SERVICE LETTER

No. 814

Piper Aircraft Corporation

Subject: Cherokee Arrow III & Turbo Arrow III Refinement Program

RIGHT SIDE VIEW OF ENGINE MOUNT

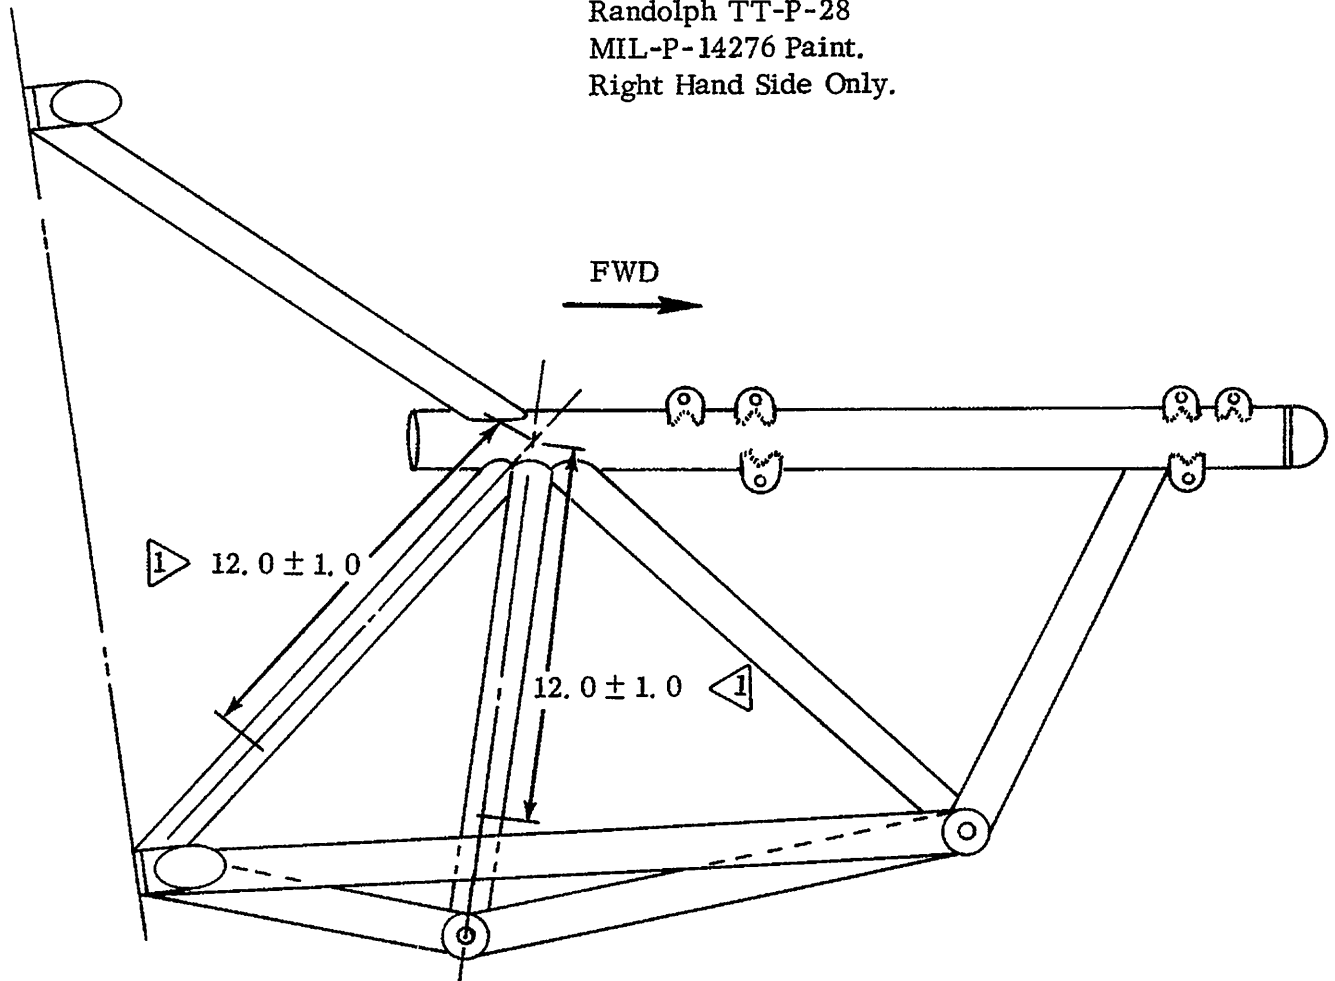
Purpose: It has been found that the engine mount paint in the area where the exhaust stack is in close proximity to the engine mount on the right hand side was deteriorating because of heat. This Service Release furnishes instructions for repainting a portion of the engine mount with a heat resistant paint.

1. Refer to Sketch "A" and completely remove all of the black paint in the area shown.

1 Clean Area Noted
and Paint With
Randolph TT-P-28
MIL-P-14276 Paint.
Right Hand Side Only.

- 2. Repaint the area from where the paint was removed with the high temperature paint listed in Material Required below.

Material Required: High temperature paint Piper Part No. 763 415V, Randolph number TT-P-28 (MIL-P-14276) @ suggested unit list price \$ 4.88G.
